Septic Repair

**ON-SITE SEWAGE DISPOSAL SYSTEM
HOWARD COUNTY HEALTH DEPARTMENT
BUREAU OF ENVIRONMENTAL HEALTH**

SITE INSPECTION SHEET

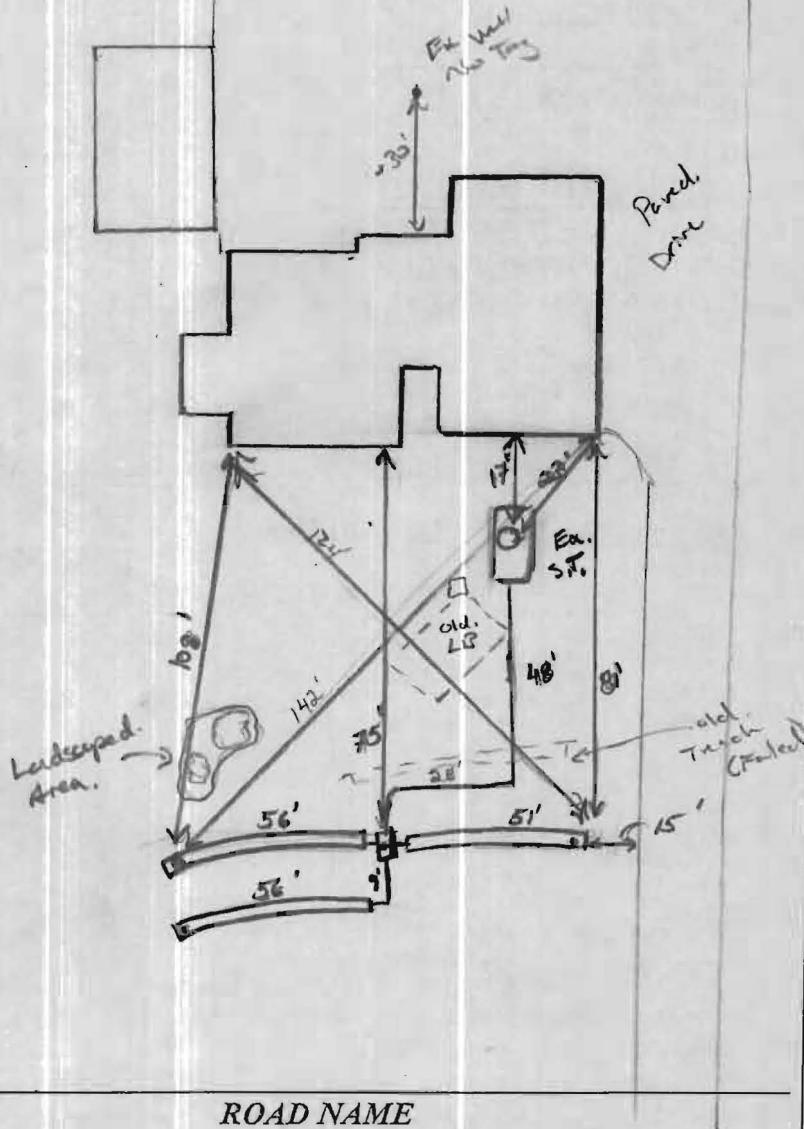
6/3/11 Plumbing installed to Dbox. All 3 trenches installed need filter cloth on trenches, obs. pipes, Dbox needs to be checked for level. (KW)
 6/6/11 Dbox leveled, filter cloth added to trenches. obs. pipes completed. System complete. OK to backfill. (KW)

LOCATION DIAGRAM

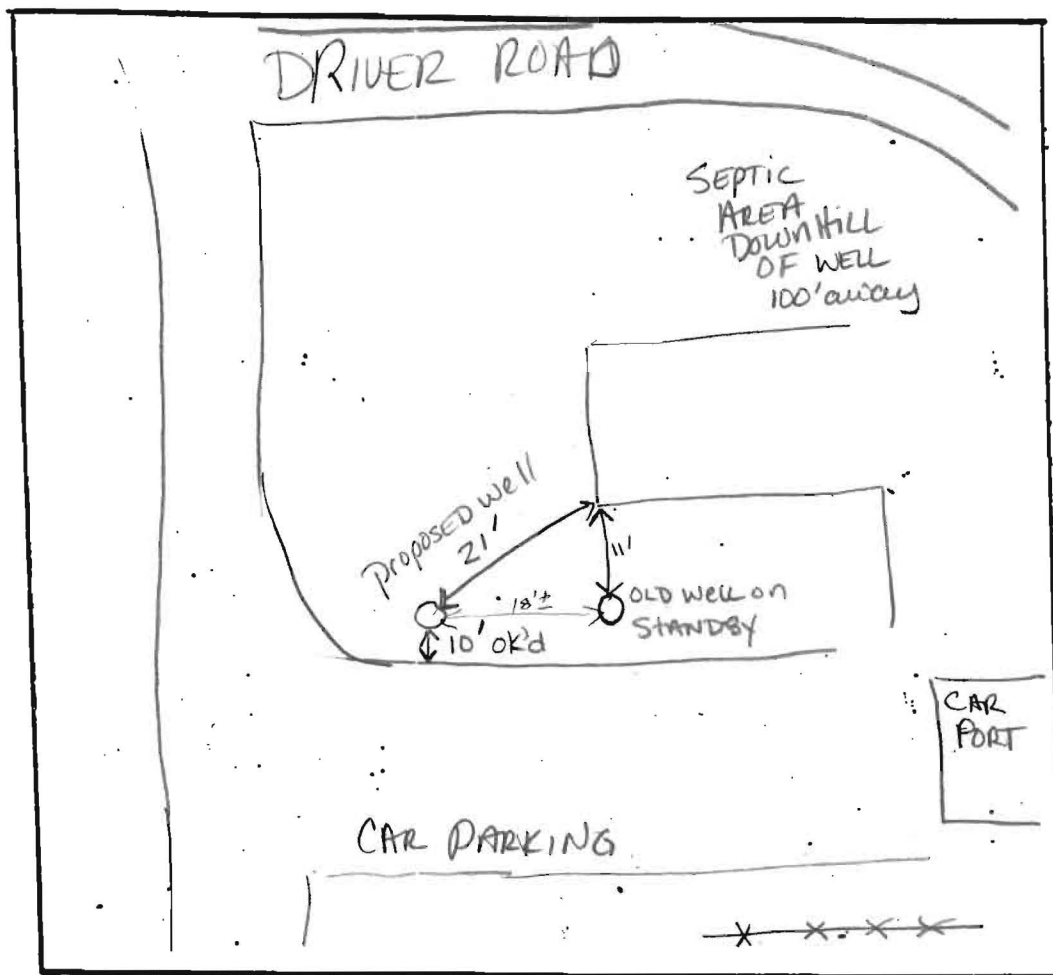
COMMENTS: 2/29/02 Keeping existing well as a stand-by.

No tag on the old well due to age of well. New site an improvement of well location

well needs tag. Received \$20 payment (Gave to Barbara)

LOCATION DIAGRAM

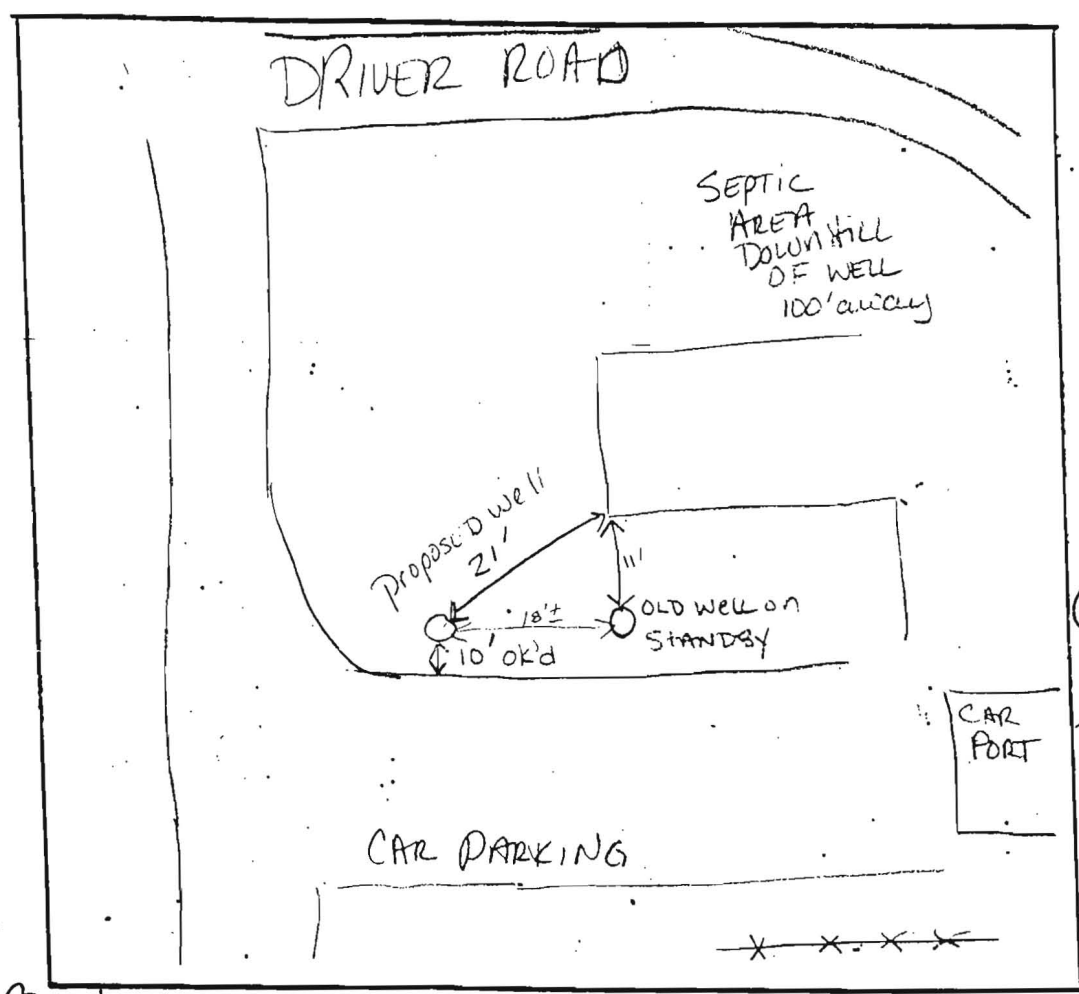
Water
Sampler
@ location
same time
I inspected
Send cl-
done &
ready
for H₂O
testing

COMMENTS: 3/1/02 Keeping existing well as a stand-by.

No tag on the old well due to age of well. New site an improvement of well location

well needs tag. Received \$ payment (Gave to Barbara)
